MONTGOMERY COUNTY PLANNING DEPARTMENT
THE MARYLAND-NATIONAL CAPITAL PARK AND PLANNING COMMISSION

MCPB
Item No.: 9
Date: 04-05-18

MARC Rail Communities Sector Plan – Worksession One

MARC Rail Communities Sector Plan Public Hearing—February 1, 2018

Figure 61

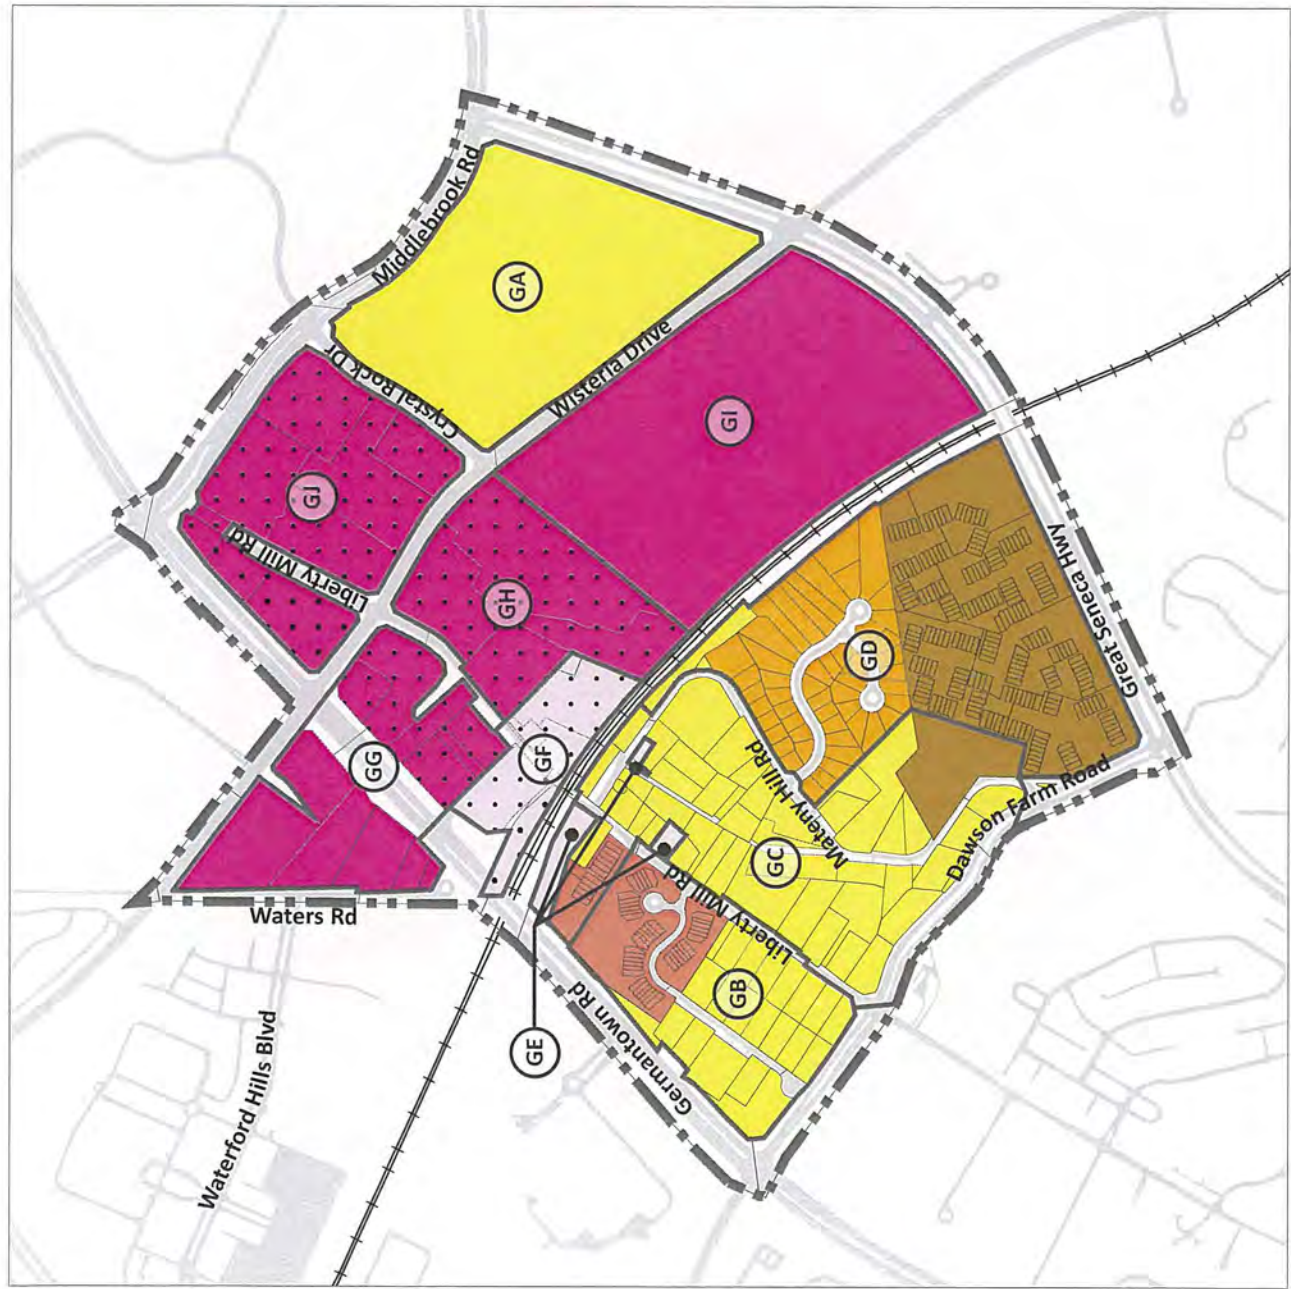
In the Working Draft, Staff recommends downzoning the Property from CRT-1.5, C-0.5, R-1.0, H-90T to CR 0.75, C-0.25, R-0.75, H-75T (*i.e.* reducing maximum permitted FAR by .75, commercial and residential FAR by .25, and building height by 25'). We understand that the intent of the Working Draft is not to downzone the Property but rather, reflect the height and density recommendations of the 2009 Sector Plan. To achieve this goal, **we are requesting that the Property be rezoned CR-1.0, C-0.25, R-0.75, H-90T.**

As noted above, the Property is currently zoned CRT-1.5, C-0.5, R-1.0, H-90T and the 2009 Sector Plan includes a recommended cap of 25 dwelling units/acre on the Property. The Working Draft proposes to rezone the Property CR 0.75, C-0.25, R-0.75, H-75T (*see* page 97). Staff recommends eliminating the 25 dwelling unit/acre cap recommended on the Property, and proposes to reduce the maximum residential FAR permitted on the Property from 1.0 to 0.75. Clark believes the density should remain as currently zoned (*i.e.* CR-1.5, C-0.5, R-1.0, H-90T).

With the elimination of the 25 dwelling unit/acre reference, Clark is willing to accept a reduction from an overall 1.5 FAR to 1.0 FAR. However, by limiting the overall development density to 0.75 FAR, the Property is in effect downzoned as there is no longer the ability to maximize residential and provide a mixed-use development as has been consistently recommended since 2009. Thus, to make the Property whole in terms of the currently permitted development density under the 2009 Sector Plan and current zoning, we are requesting that the overall FAR be 1.0 FAR, which allows for an opportunity to provide a meaningful amount of commercial development on-site. Specifically, this change would allow up to 0.75 FAR of residential and complementary commercial development up to 0.25 FAR.

- **Page 93:**
 - Zone the Property Commercial Residential **CR-1.0 0.75, C-0.25, R-0.75, H-90T 75T** (see **Exhibit "A"**); and
 - Add note to clarify that it is Staff's intention to remove the 25 dwelling unit/acre cap recommended in the 2009 Sector Plan (see **Exhibit "A"**).
- **Page 97:** **CR-1.0 0.75, C-0.25, R-0.75, H-90T 75T** (see **Exhibit "B"**);
- **Page 81:** To reflect current zoning and recommendations in the 2009 Sector Plan, remove reference to site GI (see **Exhibit "C"**).
- **Page 86:** Delete references to specific height restrictions for step-down (see **Exhibit "D"**).

Figure 2
 Boyds and Germantown MARC Station areas with walk radii

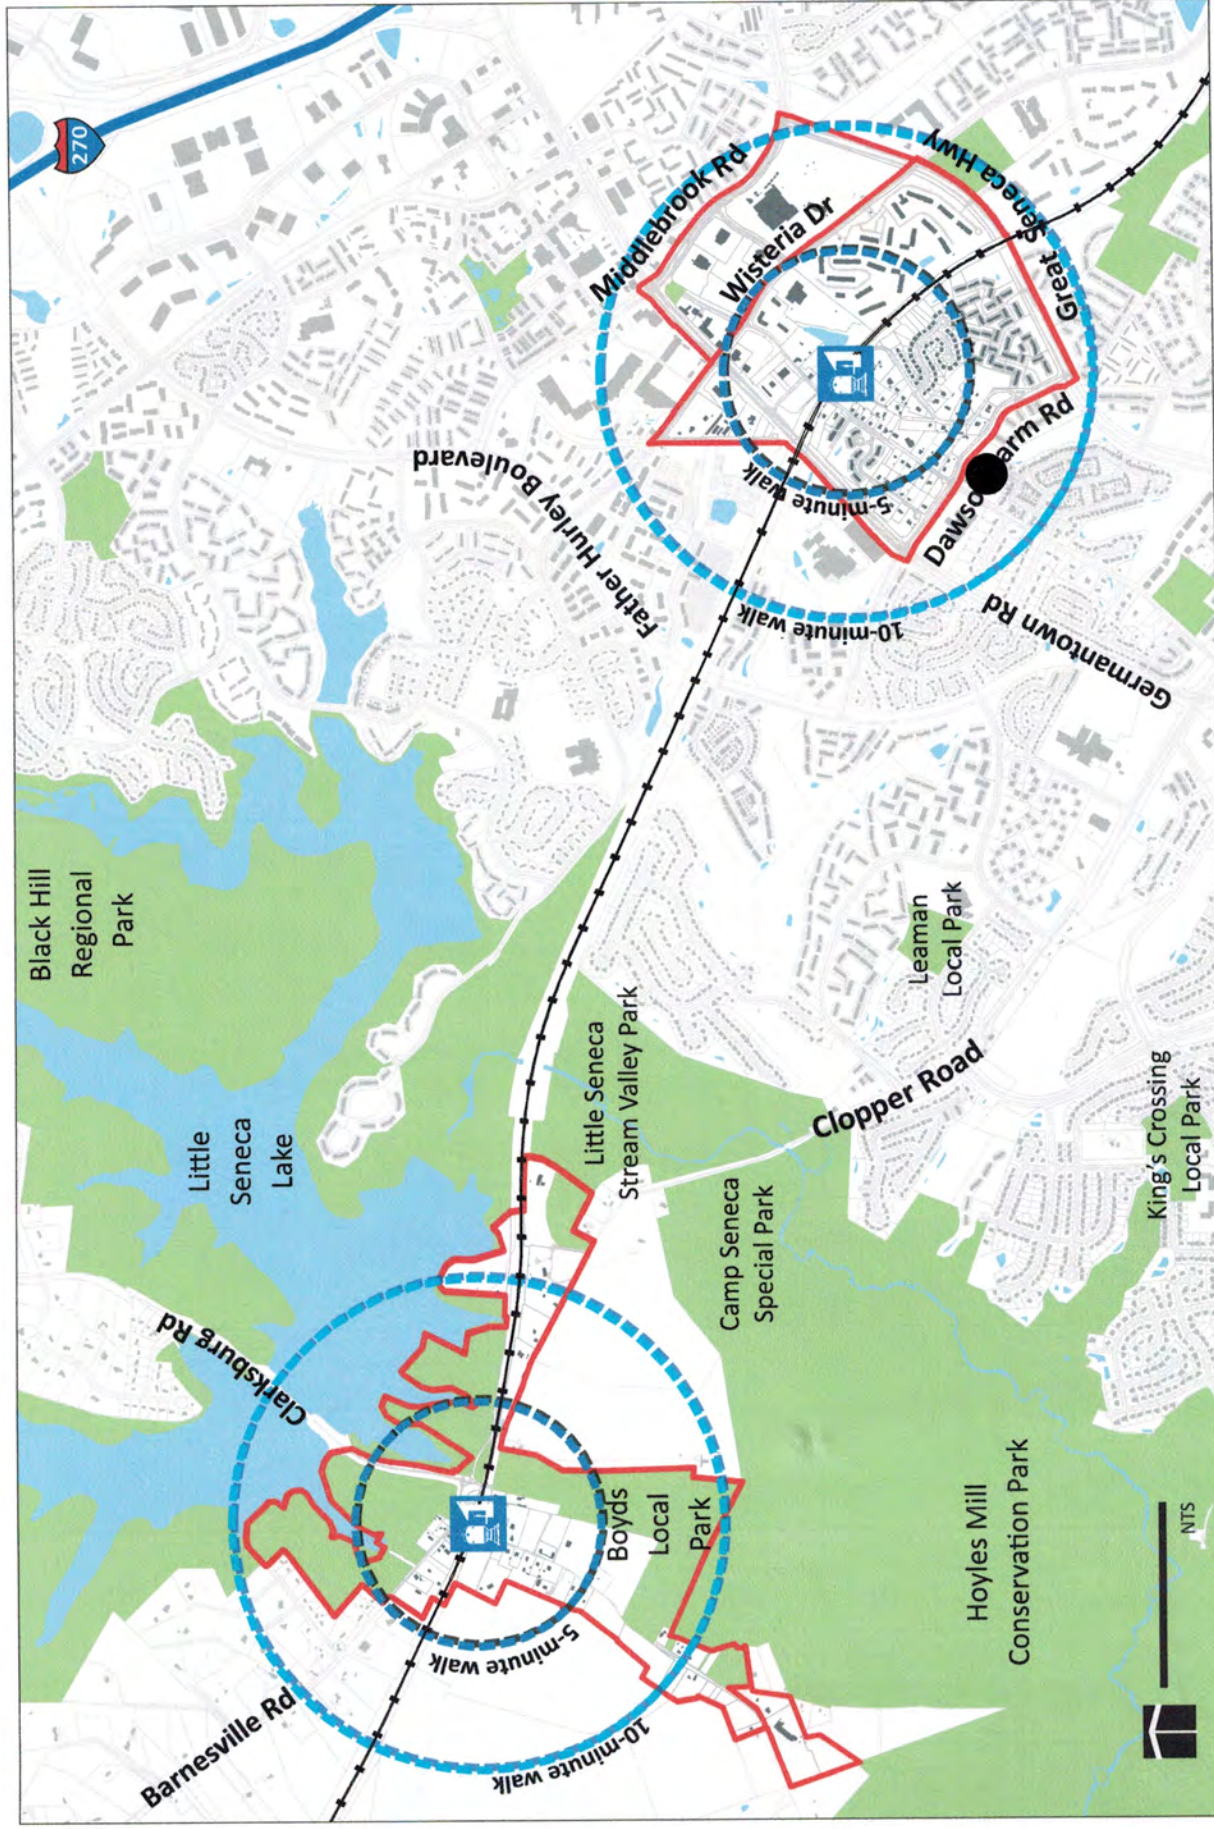
This property is just outside the boundary of the MARC Rail Communities Plan but is well within the 10-minute walk ring shown on Figure 2 and in fact is located closer to the MARC station than many properties currently included within the Plan's boundaries and is along Liberty Mill Road that is shown as a neighborhood main street on Figure 8. I have attached several exhibits from the plan indicating the location of this property with a black dot.

We are therefore requesting that the boundaries of the MARC Rail Communities Plan be minimally extended to include this property and that consideration be given to rezone this property from R-200 to RT-12.5. This new zoning classification would be compatible with the development in the area directly east of the property (townhouses) as well as with the institutional uses directly west and south of the property.
